PLAN COMMISSION AGENDA
January 14, 2019

Eau Claire Plan Commission 1/14/19 Agenda Items

STAFF REPORT

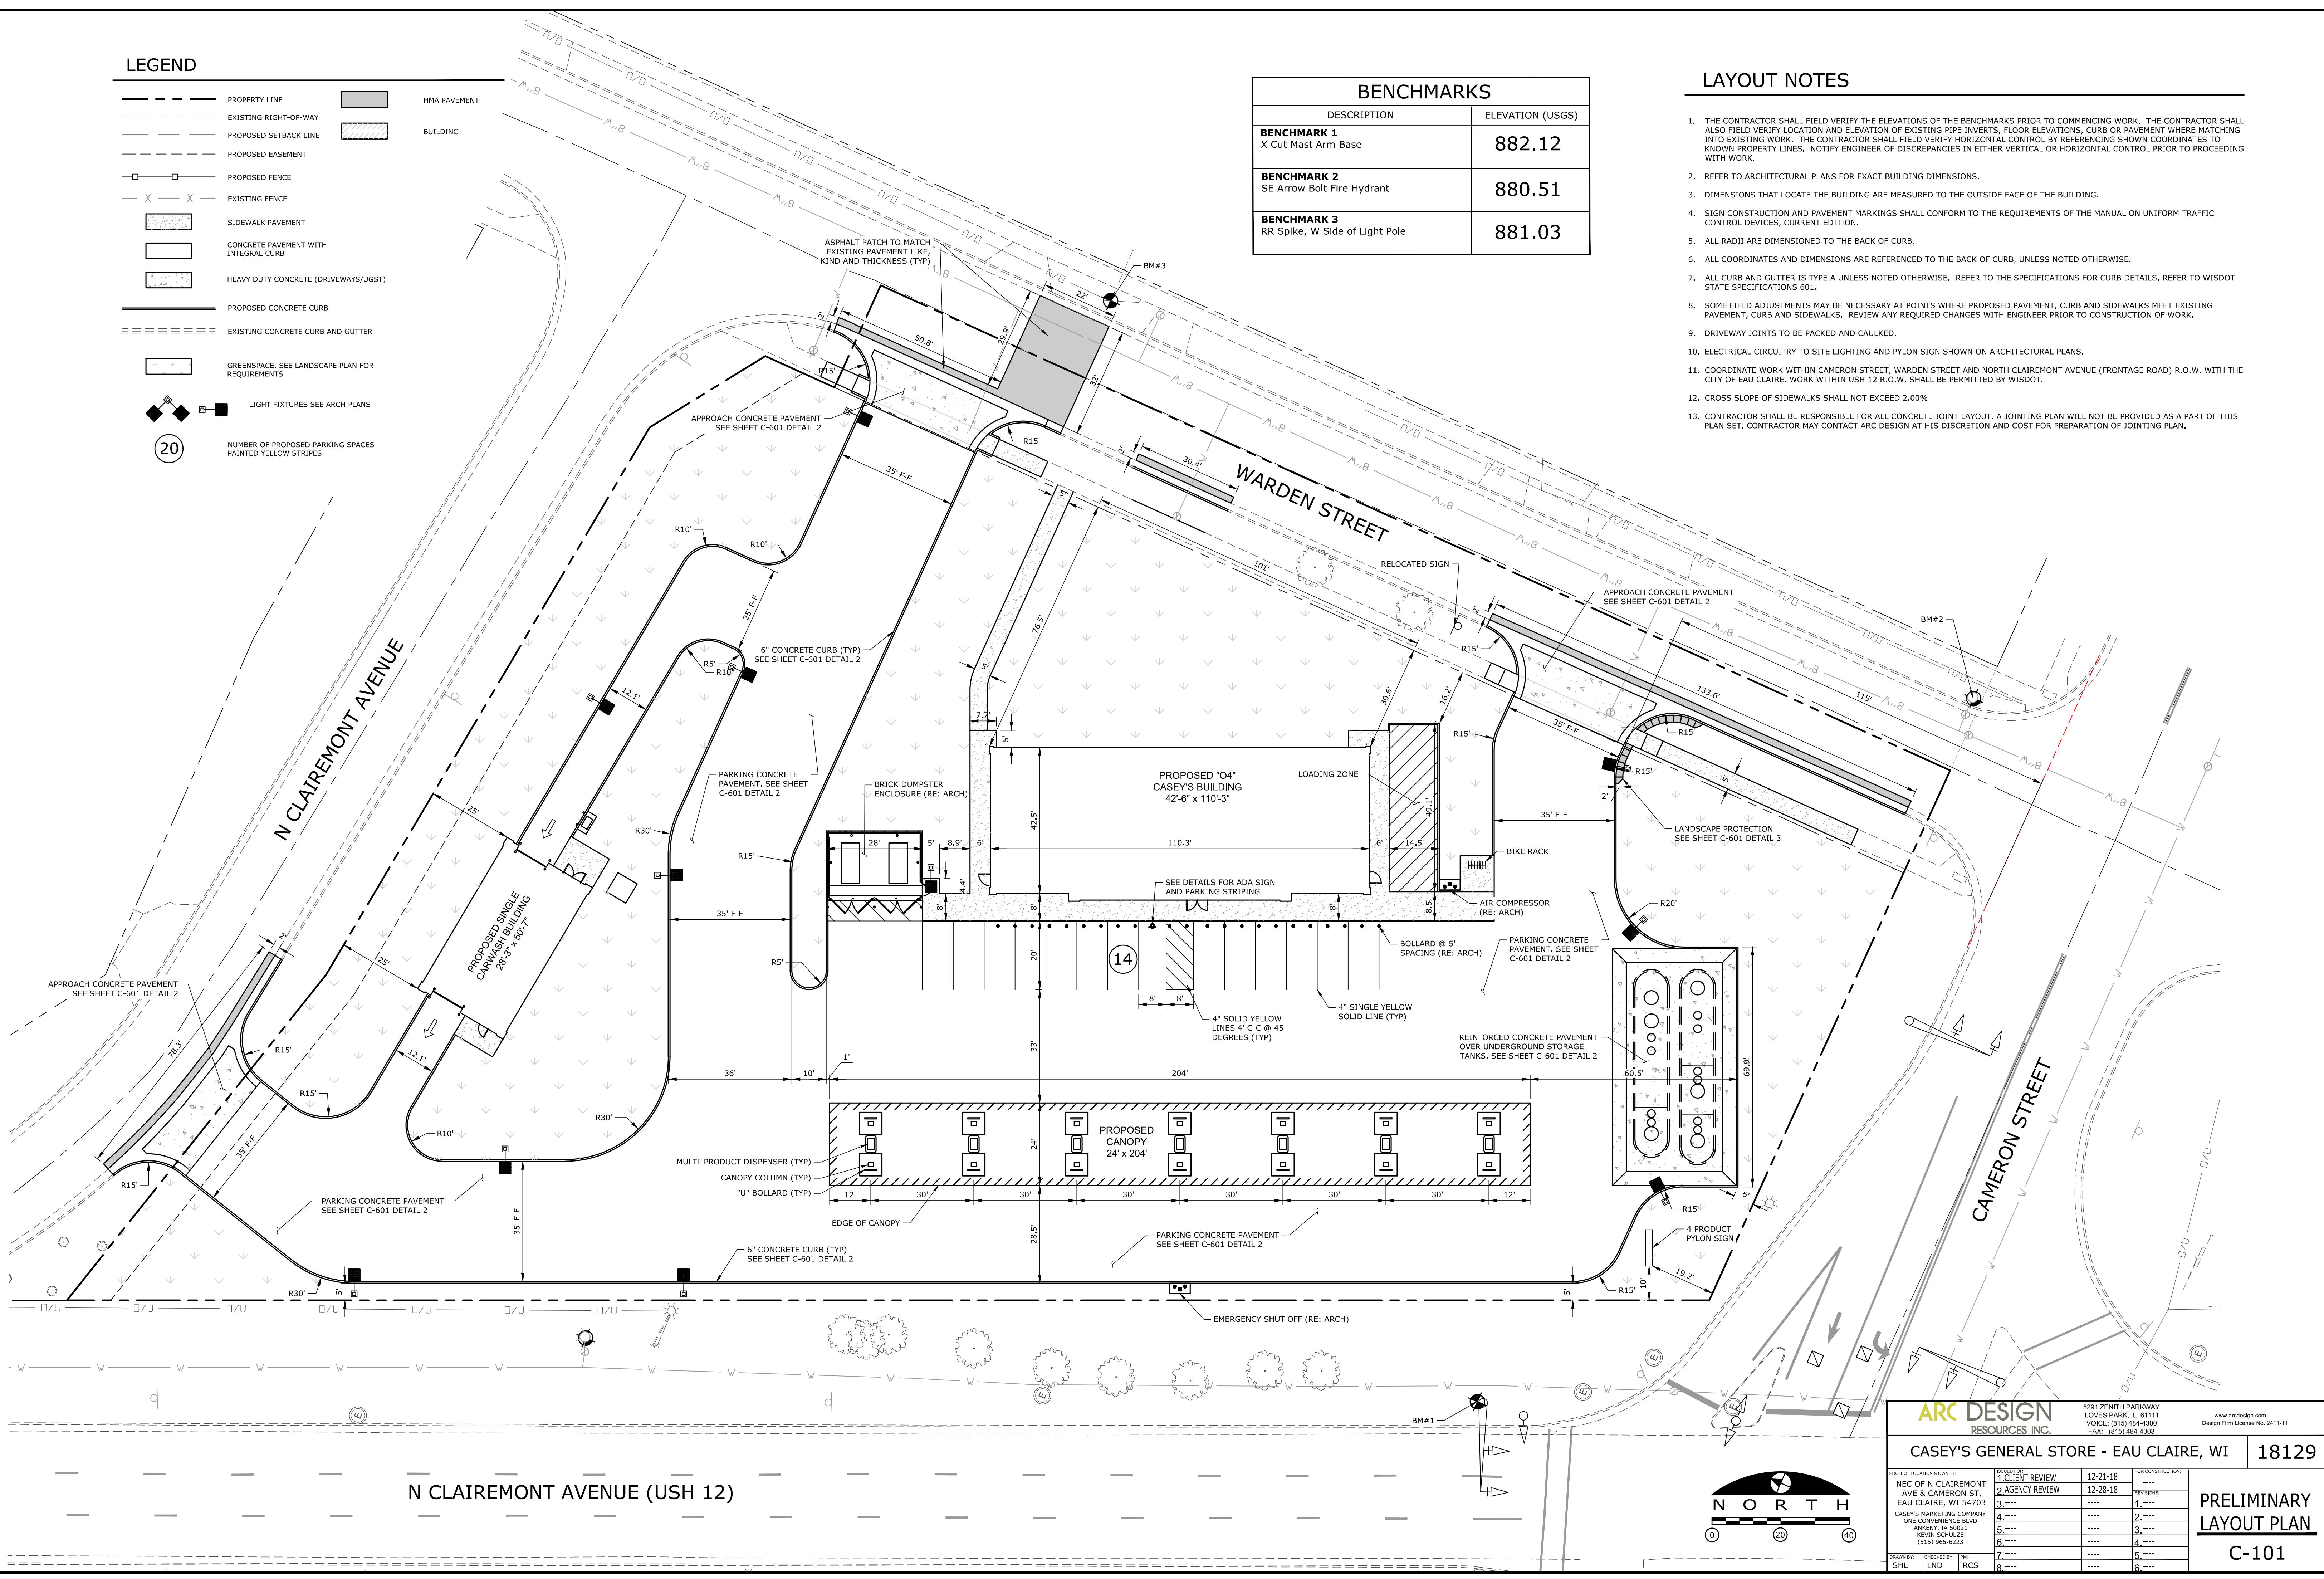
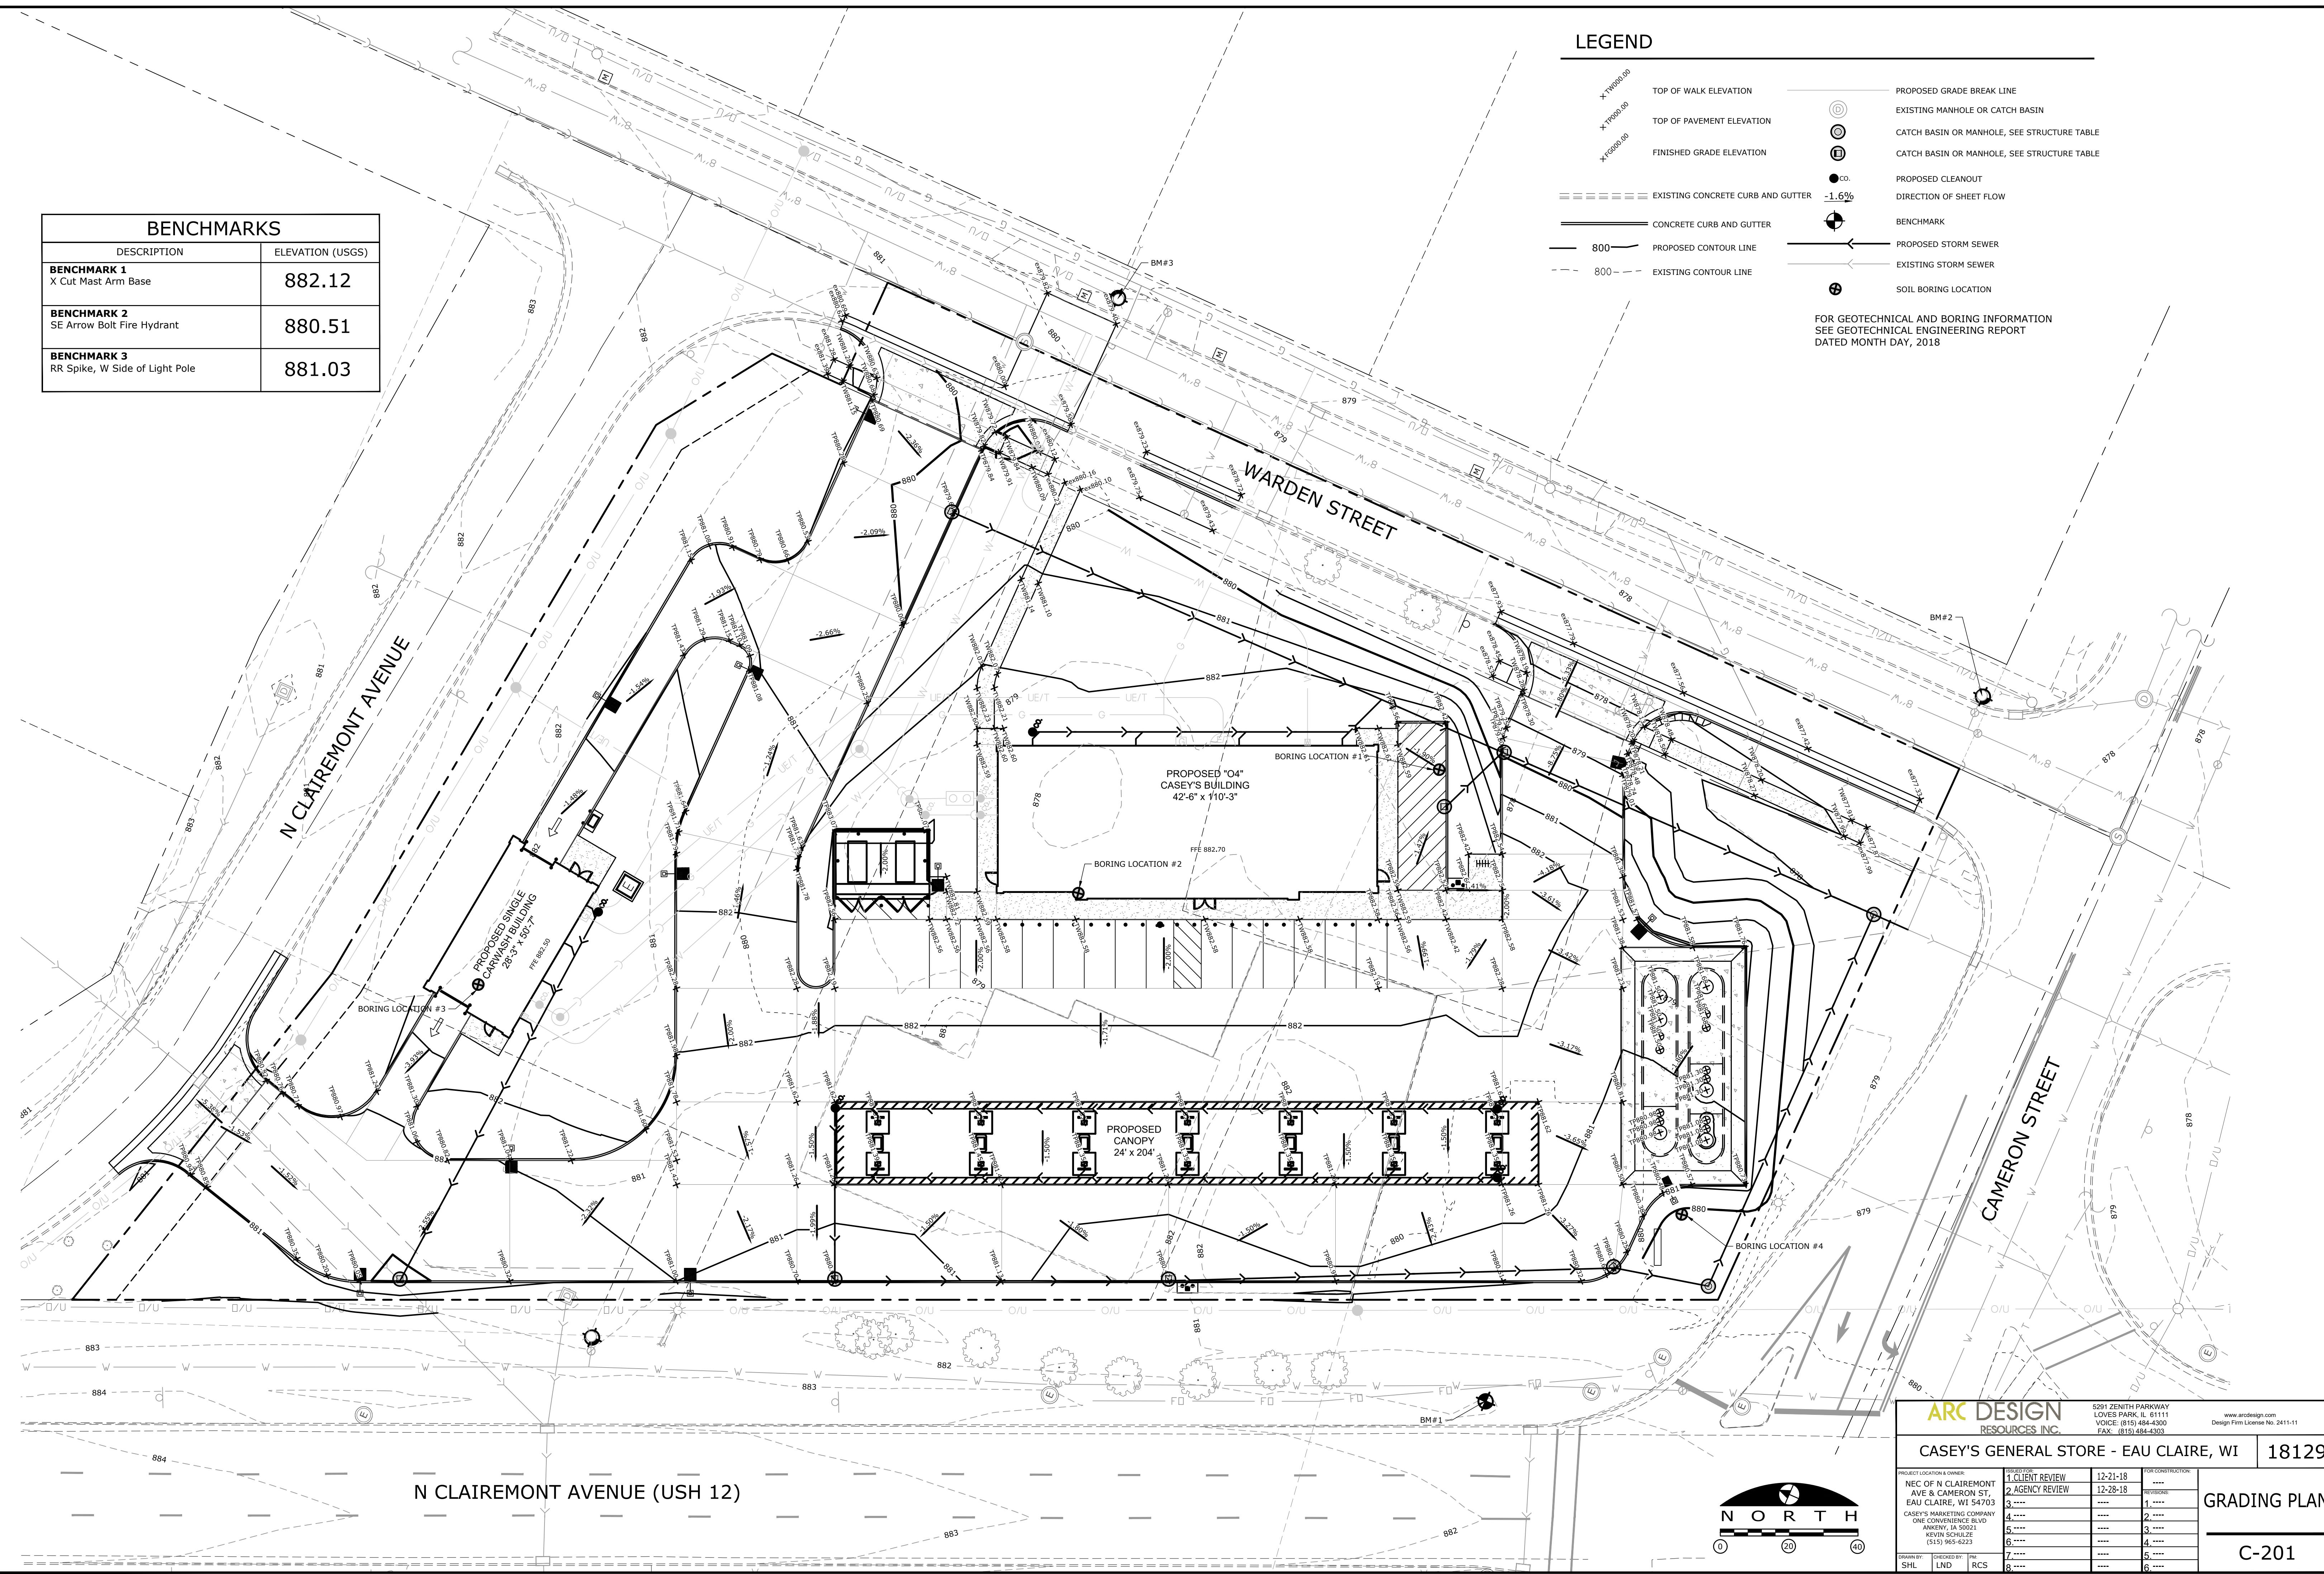
Storm water best management practices (BMP's) are required to improve runoff water quality. A sump and Up-Flo filter are proposed as the water quality BMP's. Materials submitted with the site plan indicate that in this application these units are calculated to remove approximately 45% of Total Suspended Solids. The threshold for redevelopment BMP's identified in NR151 is a 40% reduction in Total Suspended Solids. Detailed specifications must be submitted regarding the Up-Flo filter to verify water quality treatment parameters.

Traffic: The traffic generated by the proposed improvements is expected to change the traffic patterns in the area. An abbreviated Traffic Impact Analysis (TIA) should be performed on the proposed area. The goal of the TIA is to indicate the traffic impacts of the development under average traffic conditions and to identify any improvements needed to provide a level of service (LOS) "C" or better or to maintain the current LOS. WisDOT and the City will work together to review the TIA, as traffic is expected to change at intersections with USH 12 (Clairemont Avenue) as well as on the local street system. A development agreement for construction of required traffic capacity improvements may be required upon completion of the TIA review and if required, will be negotiated as a condition of site plan approval.

The plan calls for two new 35-foot curb cuts on Warden Street and one on North Clairemont Avenue Frontage Road. Curb cuts more than 30 feet require Plan Commission Approval. Section 16.36.120 "Drive Apron width-nonresidential use" of the City Code of Ordinances allows the Plan Commission to waive the 30-foot requirement:

1. City of Eau Claire Engineering Department approval of drainage calculations and drainage plan.
2. Provide a spill prevention plan for the areas where fuel is handled.
3. Plan Commission approval of the proposed 35-foot wide driveway width. (Approval of the site plan will be considered approval of the proposed 35-foot wide driveway approach. No additional actions will be required.)
4. City of Eau Claire Engineering Department approval of a Traffic Impact Analysis (TIA) following the WisDOT Initial Review (IR) process. Based on the results of the IR, the scope of the TIA will be developed with input from both the City and WisDOT.
5. Enter into a Development Agreement for Traffic Capacity Improvements, as determined by the Traffic Impact Analysis.
6. Ground sign will need to be moved to meet the proper setbacks and is reviewed with a sign permit.
